# **Parramatta over and adjacent station development**

## **Addendum Station Utilities & Infrastructure Servicing Assessment**

**Document Number:** SMWSTEDS-SMD-PTA-SN600-CV-RPT-044003

**Figure 3-1 Pre-development site plan with building profiles**

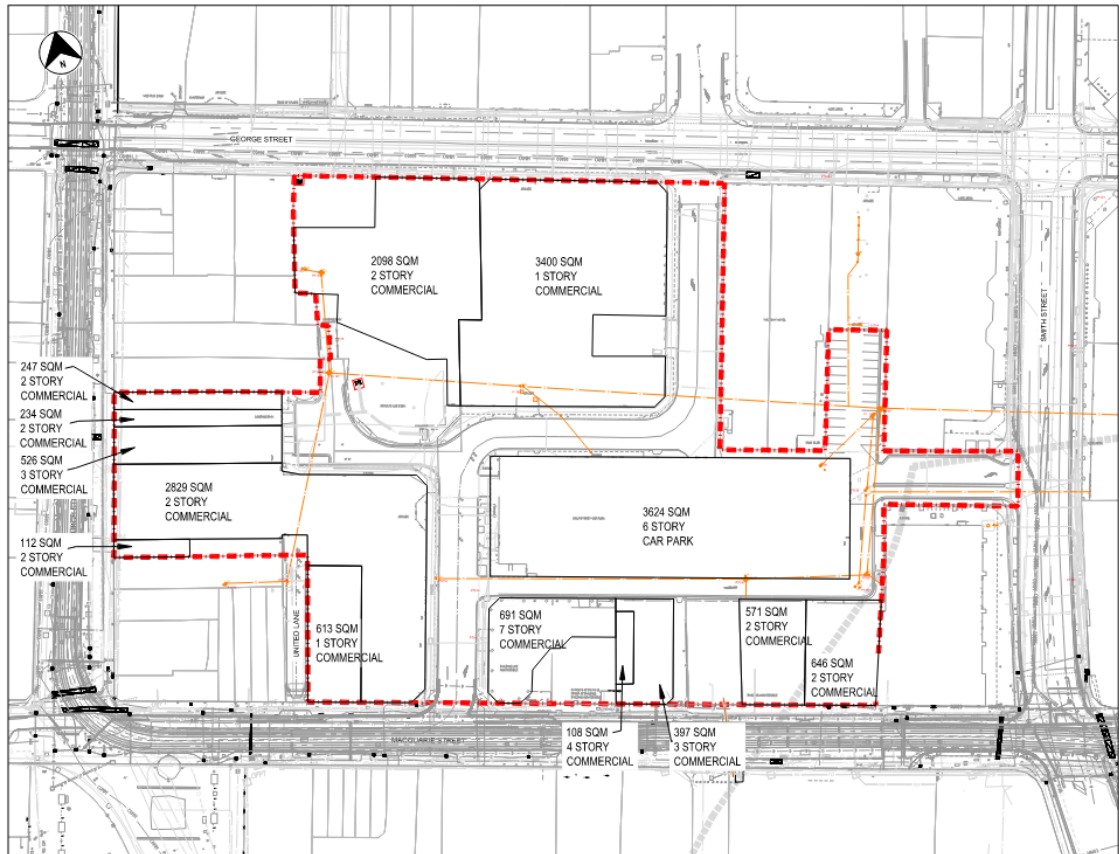
- *The proposed development is within Parramatta SCAMP and is a part of the North Head System. The existing wastewater system should have adequate capacity to service the proposed development.*
- *There is a high-risk overflow structure downstream which could be impacted by the additional discharge resulting from the proposed development. In accordance with EPA requirements, the volume and frequency of spills from high-risk structures should not increase from the baseline.*
- *Due to the constraints above, the proponent must engage a hydraulic consultant to demonstrate that the current performance of the wastewater system does not deteriorate in both dry and wet weather because of the additional demand required from the proposed development. We recommend that this process be started as early as feasible to reduce any construction delays.*

Sydney Water has advised that there is a high-risk overflow structure downstream, which could be impacted by the additional discharge from the proposed development. In accordance with EPA requirements, the volume and frequency of spills from high-risk structures should not increase from the baseline. Due to this constraint, Sydney Water has advised the proponent to demonstrate that the current performance of the wastewater system does not deteriorate in both dry and wet weather because of the additional demand required from the proposed development.

A high-level investigation and calculations were made to estimate the pre-development wastewater discharge. The difference between pre-development and post-development wastewater discharge was identified to guide the required capacity of wastewater detention tanks to prevent overwhelming the existing wastewater system.

An assessment of the catchment profile of the existing site condition has been undertaken to determine the current/existing wastewater outflow from the site. This assessment confirms the baseline condition for the next step of the hydraulic analysis. Figure 3-1 below shows the existing catchments/buildings where wastewater from these catchments/buildings discharge to the existing Sydney Water wastewater network. An estimate of GFA has been calculated based on the topographical survey information and/or aerial photo. With the use of Google Street View, number of floors have been calculated for each of the catchments/buildings to calculate the total GFA for each of the catchments/buildings.
